**CITY OF BLOOMINGTON
PLAN COMMISSION
July 12, 2021 at 5:30 p.m.**

SP-15-21 **Trinitas Ventures**
3216 E 3rd Street
Request: Site plan approval to allow the construction of a multi-family residential development with 340 dwelling units and 906 bedrooms.
Case Manager: Eric Greulich

**BLOOMINGTON PLAN COMMISSION
STAFF REPORT – SECOND HEARING
Location: 3216 E 3rd Street**

The District at Latimer Square Bloomington, Indiana Site Plan Approval

BIKE AND CAR PARKING LOCATIONS

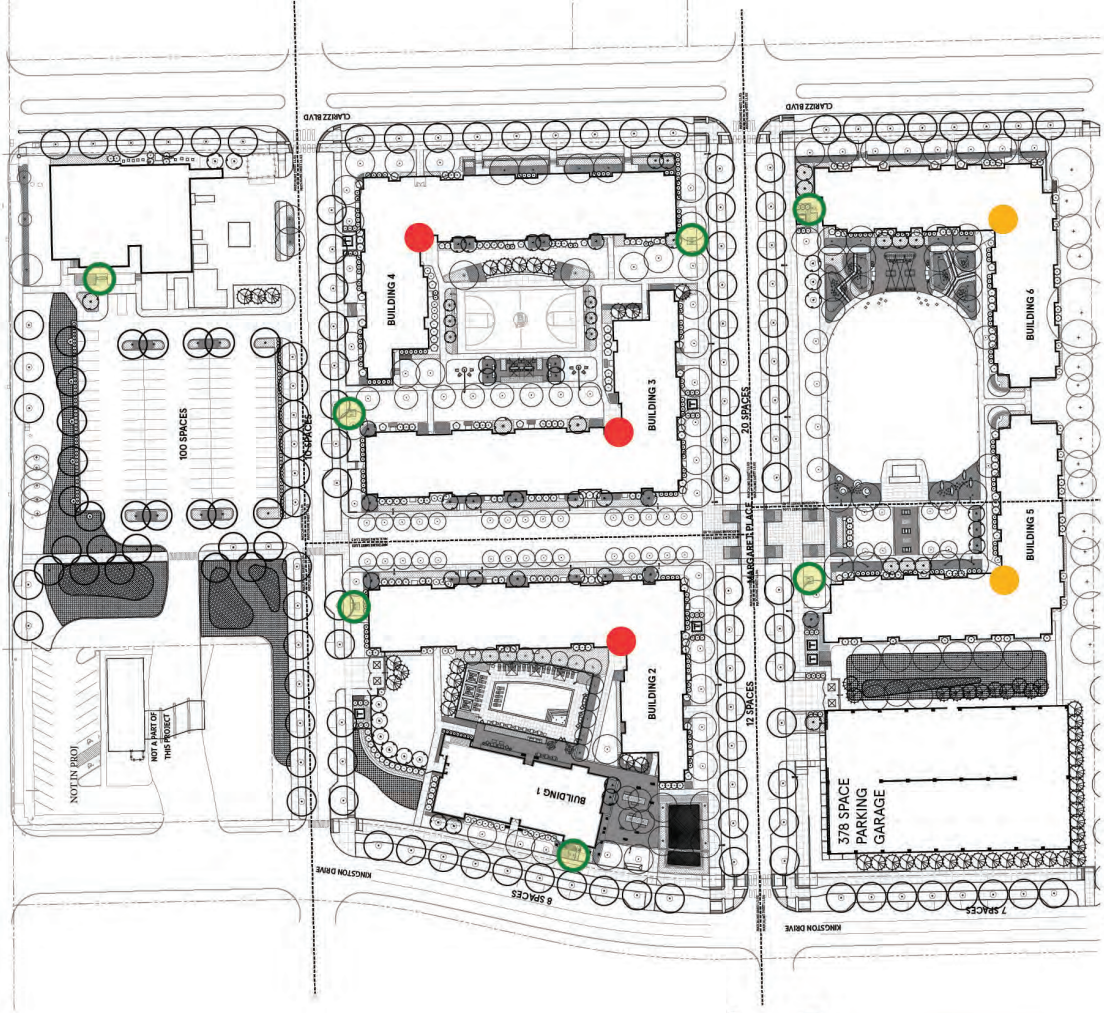
10. Bike parking at Bloomingfoods entrance looks insufficient / is not illustrated in enough detail. 4 bike spaces is

Please see Sheet A004 for parking demand calculations and parking supply. Street parking on Claritz has been removed.

PREVIOUS PLAN COMMISSION SUBMITTAL
**MULTI FAMILY BUILDINGS 566
END CAP FACADE FACING MARGARET PLACE**

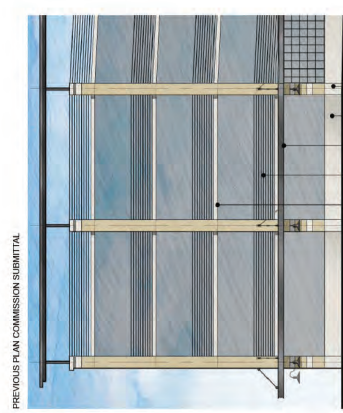
- The west elevation and other large expanses should receive additional study. Visual interest and start to break down the scale of the elevation, but more opportunity should be considered to strengthen the impact of these elements. Possibilities could include widening the pilaster elements, wrapping the pilasters with block masonry units to visually tie them to the residential buildings and/or infilling the areas between the pilaster with a metal mesh or other semi-transparent material to give the elements a more substantial visual presence. This type of application could also feature public art or a branding element for the development.

- The open storefront framing shown in the lower areas of the west elevation should be reconsidered. Discuss options to this approach with the Planning Department, including consideration of perforated metal panels which could have water jet-cut patterns with opening shapes or themes that relate to the branding or strong design character of the rest of the development.

- Paneled Glazing with Bi-graftic Patterns at corner up to top level (reference to Latimer Woods)
- Corner facing Kingston and Margaret Place Drive glazed up to parapet guardrail
- Precast cornice expression replace canopy
- Precast columns now four feet in width (double)
- Precast spandrels change color on facade bays with raised cornice to accentuate facade rhythm
